Planning Commission Regular Meeting

Planning Commission Staff Report

Subject: Stouffer Residence Landmarking, Restoration, and Addition
(Class A Major Development Permit, Preliminary Hearing; PL-2025-0355)

Proposal: A proposal to locally landmark and rehabilitate an existing historic primary residence, demolition of the non-historic saltbox addition, and a new addition in the rear of the lot. The project proposes 3,668 sq. ft. of total density which includes three (3) bedrooms, five (5) bathrooms, an office, an accessory dwelling unit (430 sq. ft.), and a two-car garage (500 sq. ft.). The historic barn will also be fully rehabilitated. The project includes (1) one gas fireplace and 489 sq. ft. of heated paving and walkways.

Site Plan,
Roof Plan,
Landscape Plan
Scale 1/8" = 1'-0"

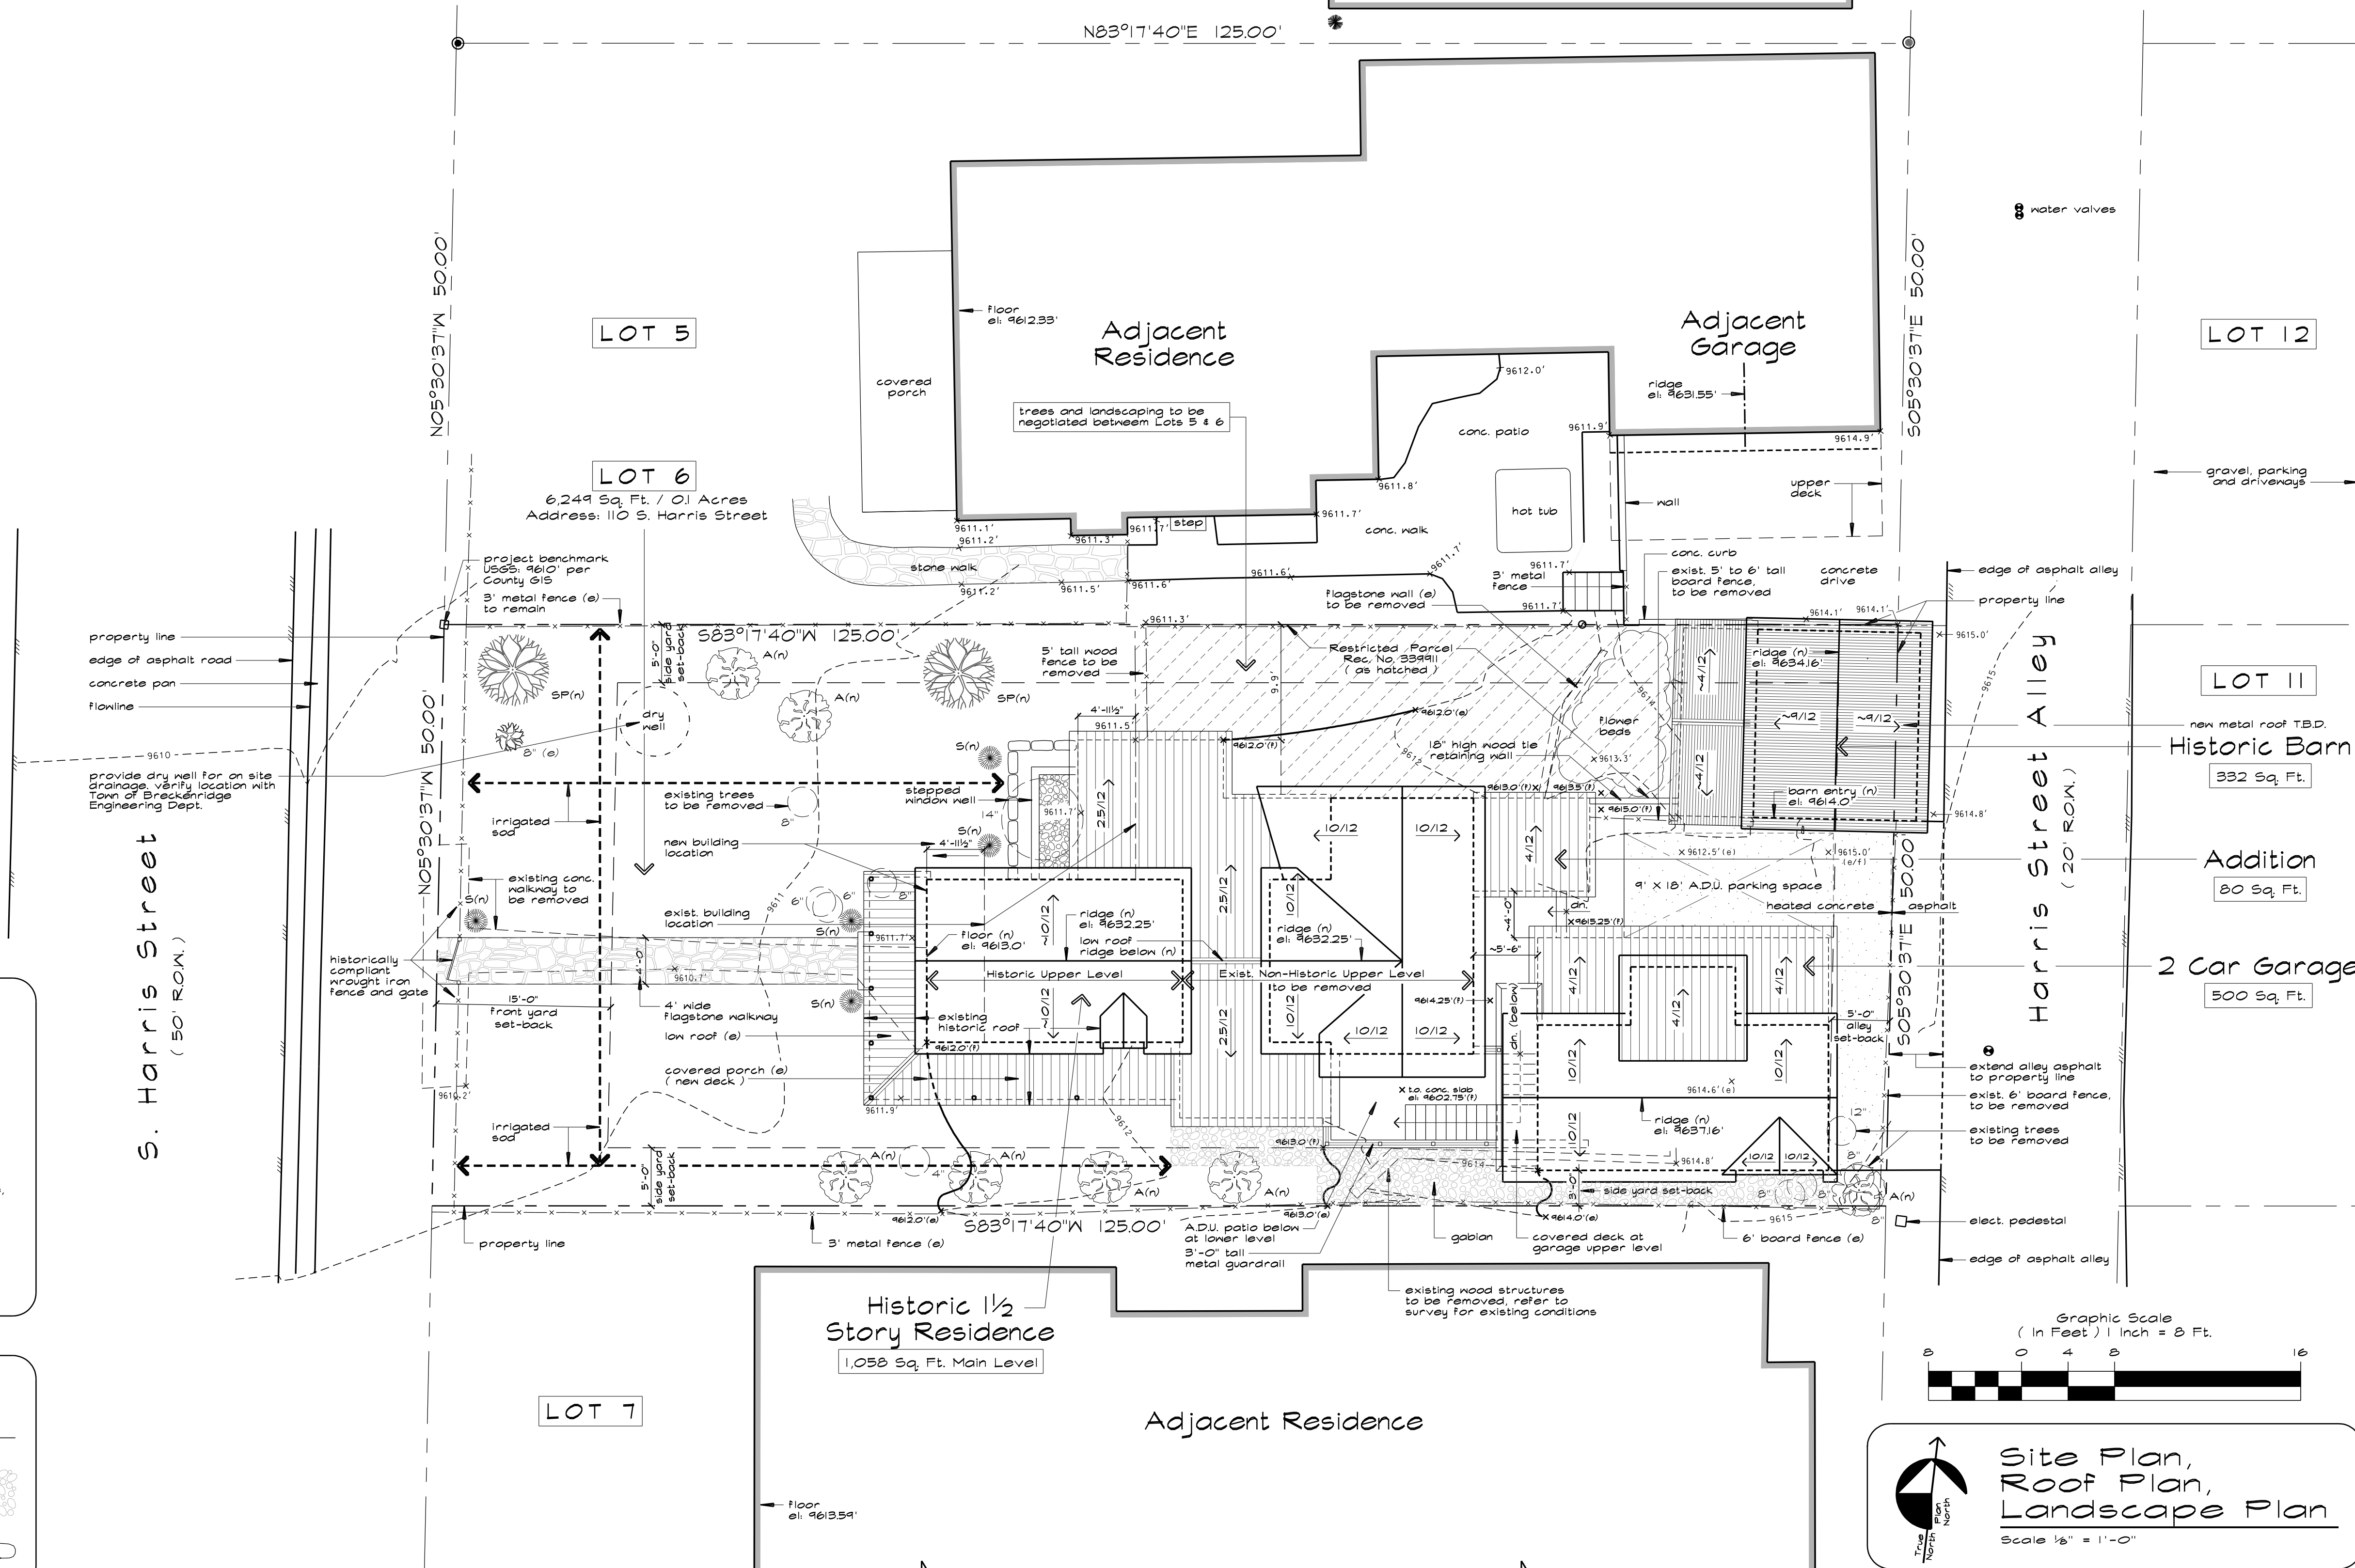
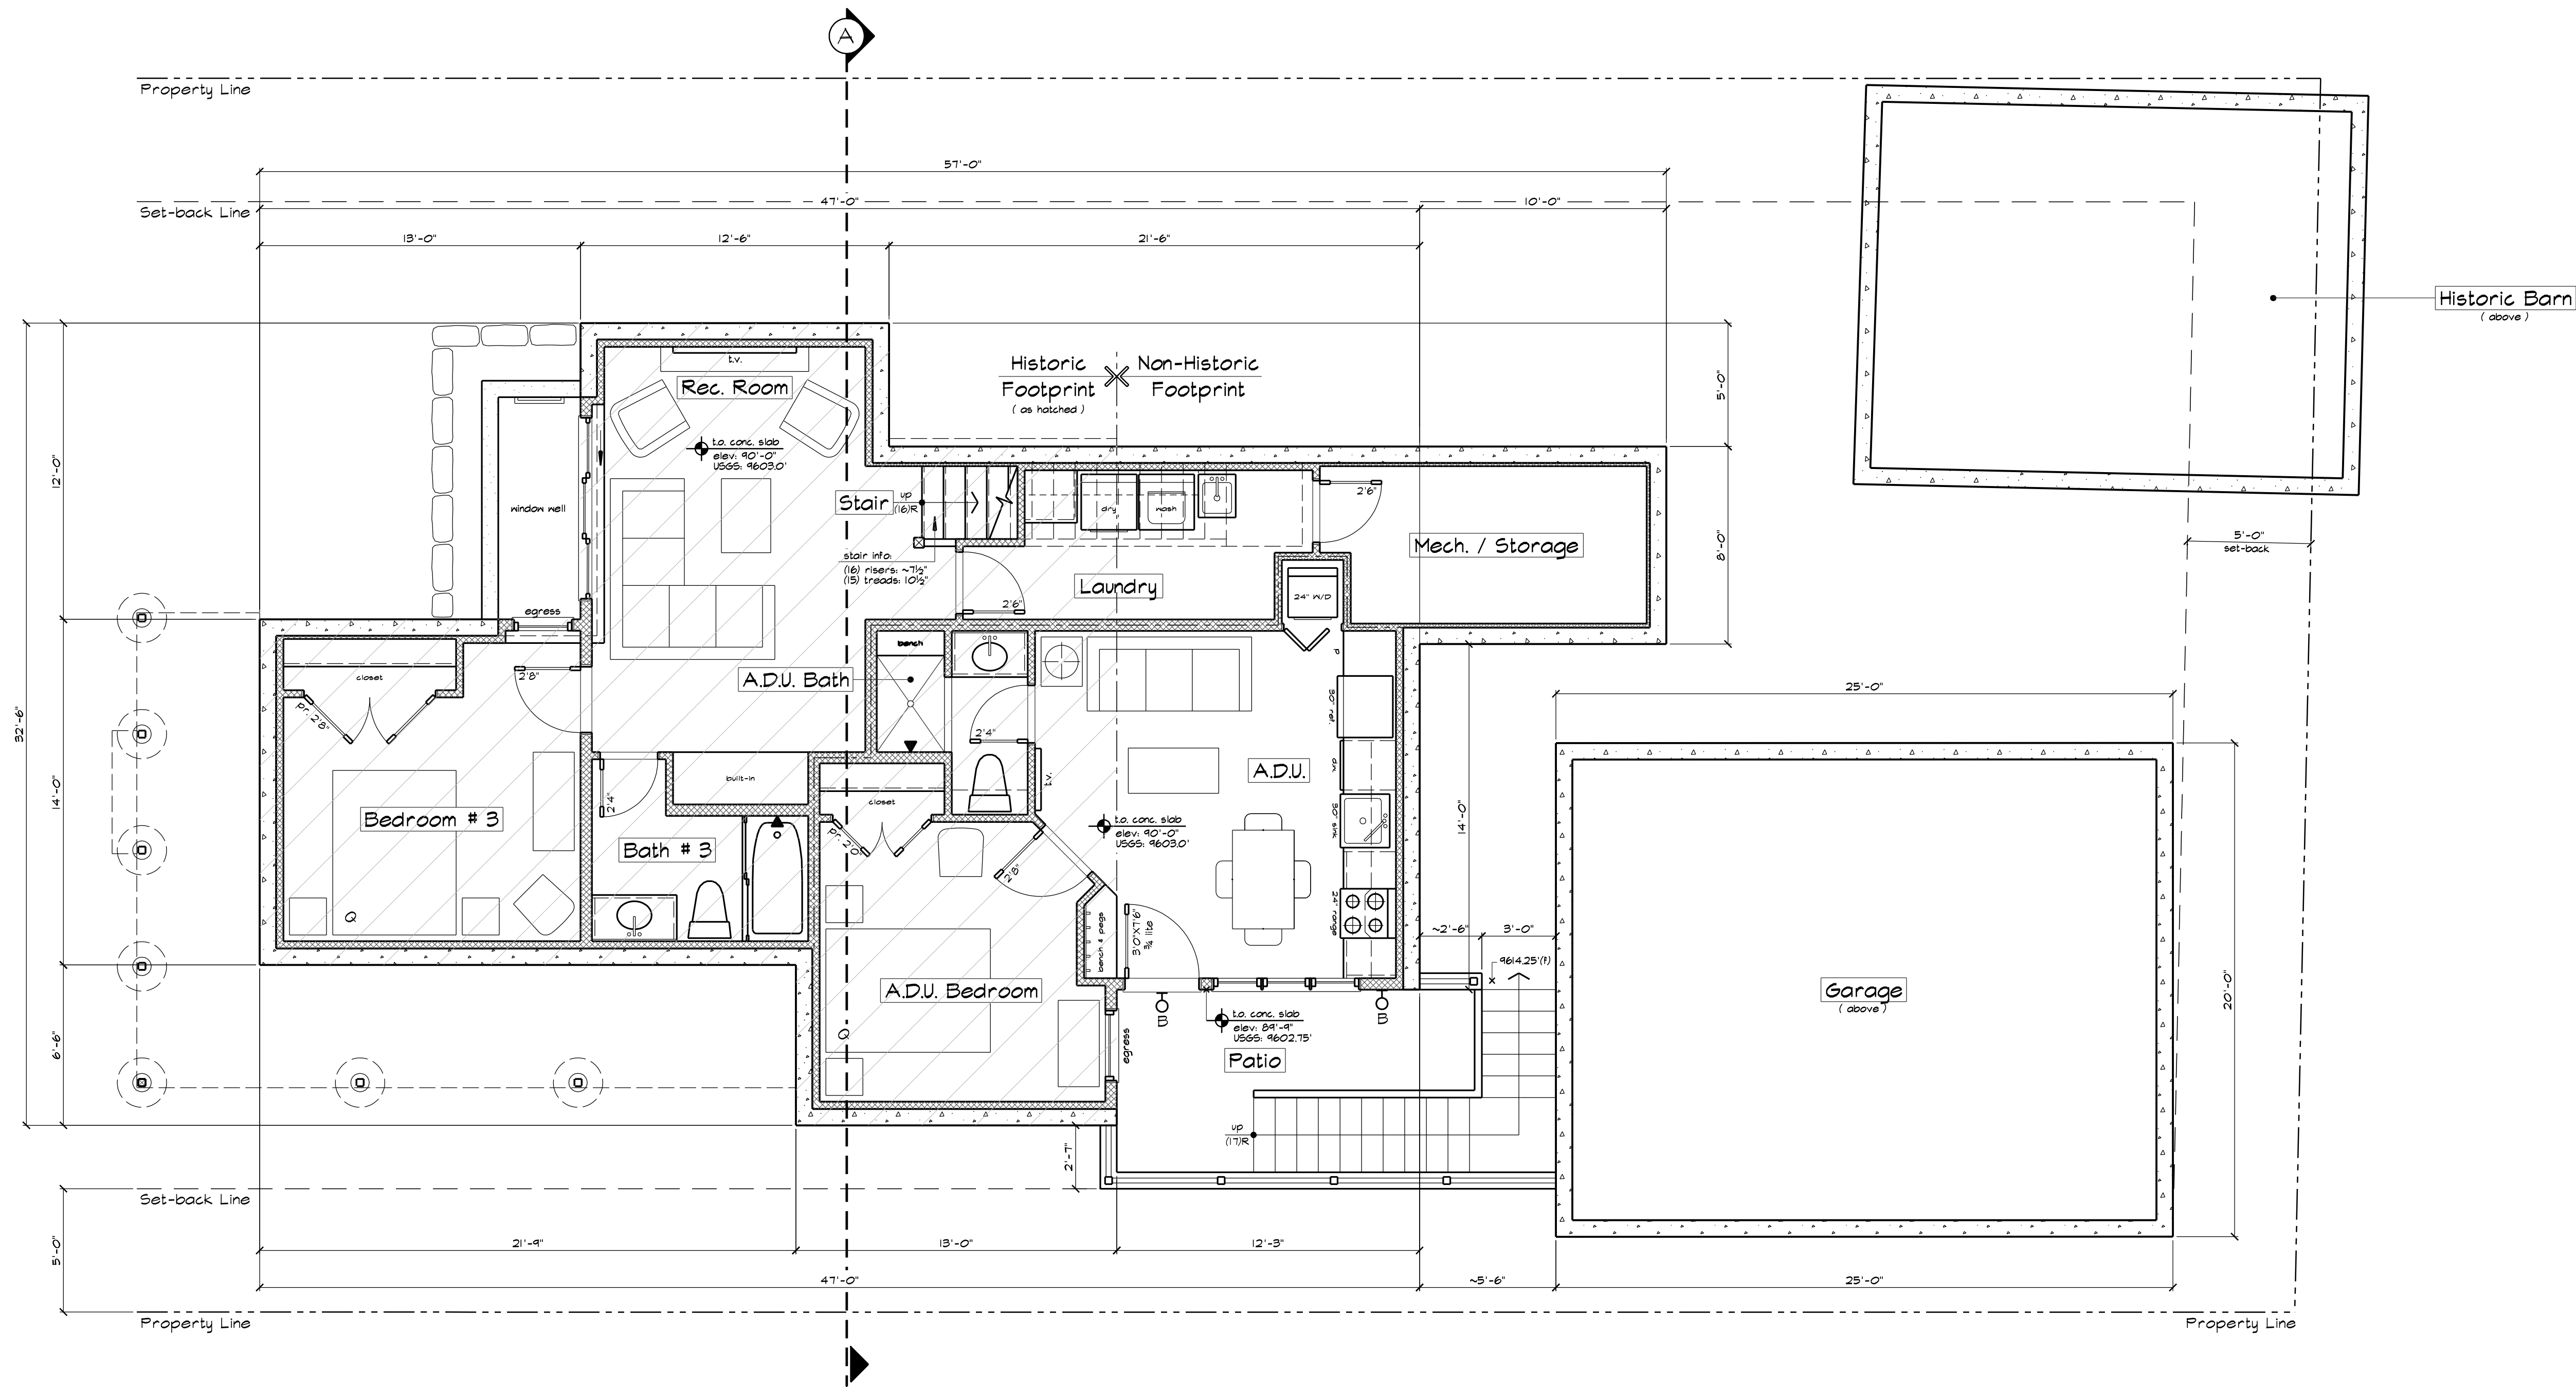
Site and Environmental Design (7/R): The project will remove all existing site improvements, including front-yard parking and landscaping, to accommodate a rear addition and a two-car detached garage with associated paving and circulation (approx. 418 sq. ft.). While most of the site will be disturbed for construction and drainage improvements, the historic front yard remains open space, and staff finds the revised layout visually harmonious and consistent with Policy 7/R.

The proposed detached garage is located at the minimum required setback for the rear alley setback (5') and southern side (3') setback with the roof eaves projecting up to an additional 18” into the required setbacks without penalty per [9-1-19-9A\(C\)\(1\)\(d\)](#). The detached structure is otherwise complaint with the front and northern side setback. Due to not meeting two of the relative setbacks, staff has assigned negative six (-6) points per [9-1-19-9R\(D\)\(1\)](#).

Staff notes that the proposed landscape plan includes approximately 2,300 square feet of sod, which is a significant area. At this time, the applicant has not provided details regarding the type of sod or whether the installation will require permanent irrigation. This information is necessary to determine if the proposal warrants negative points under the applicable code, which identifies large areas of sod and irrigation as examples of providing no public benefit. Staff requests clarification from the applicant on these items before completing the point analysis.
